L-MT-07-088
10 CFR 50.90

Monticello Nuclear Generating Plant
Docket 50-263
Renewed Facility Operating License No. DPR-22

Response to Request for Additional Information to Revise TS Surveillance Requirement
3.5.1.3 to Correct the Alternate Nitrogen System Pressure (TAC No. MD4095)

MONTICELLO NUCLEAR GENERATING PLANT
 FIGURE 1 ALTERNATE NITROGEN SYSTEM

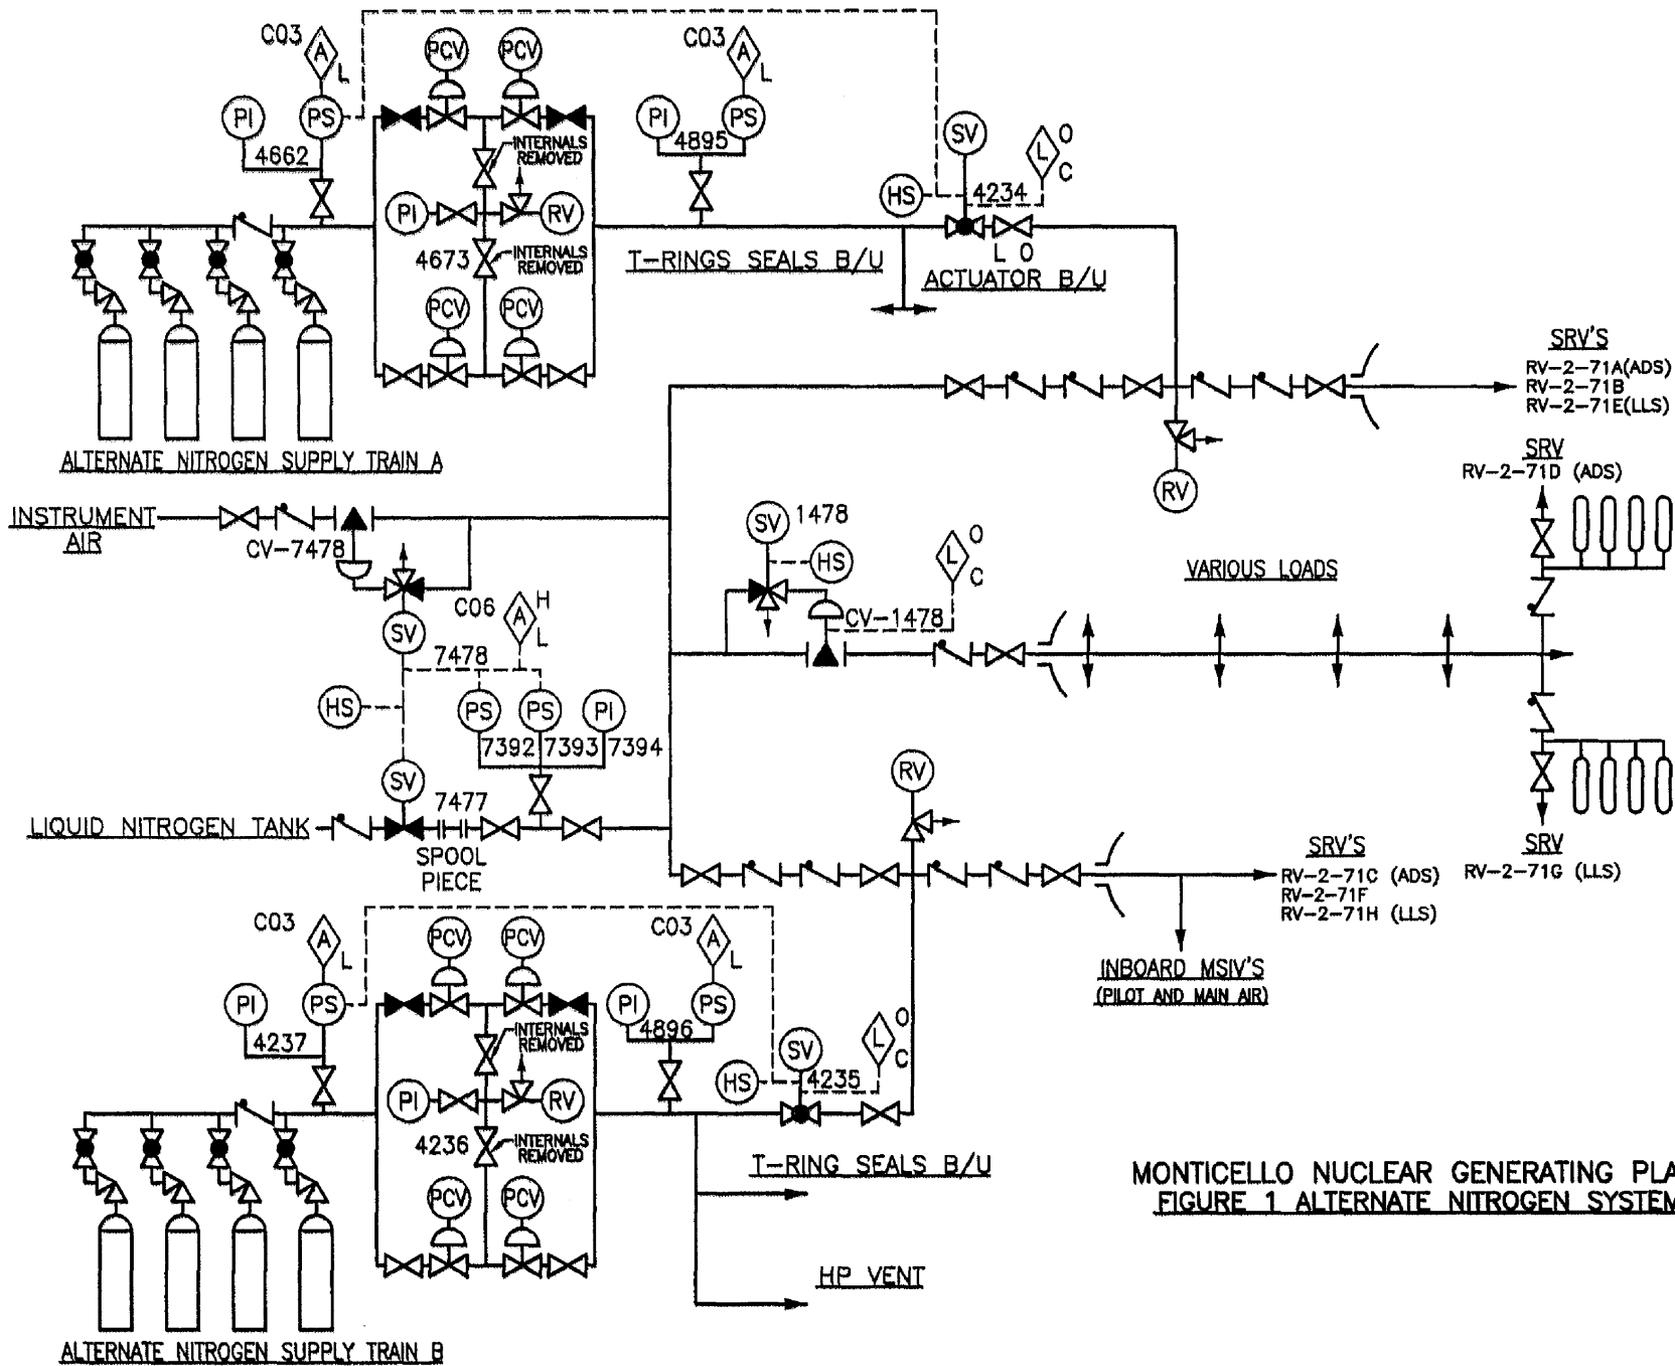
Summarize the calculation, including the assumptions and results, which would justify why 410 psig is the correct number. The submittal should make it clear that 410 psig is a conservative value, in that a supply pressure of 410 psig ensures that the Alternate Nitrogen System can perform its safety function of actuating the SRVs (for the ADS function) during a LOCA by depressurizing the reactor vessel to permit low pressure ECCS injection, and that a supply pressure of 410 psig is adequate for more SRV actuations than is required under worst-case situations.

The AN2 System provides an automatic safety-related, long-term, backup pneumatic supply upon a loss of the non-safety related Instrument Nitrogen system distribution. System leakage during normal plant operation is made up for by the Instrument Nitrogen System. The AN2 System consists of an 'A' and 'B' subsystem. A diagram of the AN2 System is provided as Figure 1.

The A AN2 subsystem serves the T-ring seals on four containment purge and vent valves; the actuators and T-ring seals for two containment vacuum relief valves; and safety relief valves (SRVs) A, B, and E. The B AN2 subsystem supplies the T-ring seals for three containment purge and vent valves; the hard piped vent valves; the inboard main steam isolation valves (MSIVs); and SRVs C, F, and H.

An isentropic expansion (no change in entropy) of the nitrogen as it exits the bottle was assumed.⁽⁵⁾ The minimum pressure for subsystem operability is 250 psig. An iterative solution to determine the bottle/manifold initial pressure, prior to the assumed subsystem loads being applied was required. It was determined that for an initial bottle pressure of 410 psig, an isentropic expansion would result in a final pressure of 256 psig. Since 256 psig is greater than the required minimum pressure for system operability of 250 psig, it was determined that 410 psig was an acceptable minimum AN2 subsystem manifold supply pressure.

Since each AN2 subsystem provides sufficient capacity at the minimum manifold pressure of 410 psig to supply all subsystem loads, i.e., meet its design and safety functions for the various equipment served, the AN2 System can perform its safety function of actuating the SRVs (for the ADS function) during a LOCA by depressurizing the reactor vessel to permit low pressure ECCS injection. Each AN2 subsystem provides sufficient volume to cycle the three⁽⁶⁾ supplied SRVs five times each (15 cycles), while supplying the other loads on the subsystem, without nitrogen bottle replacement.
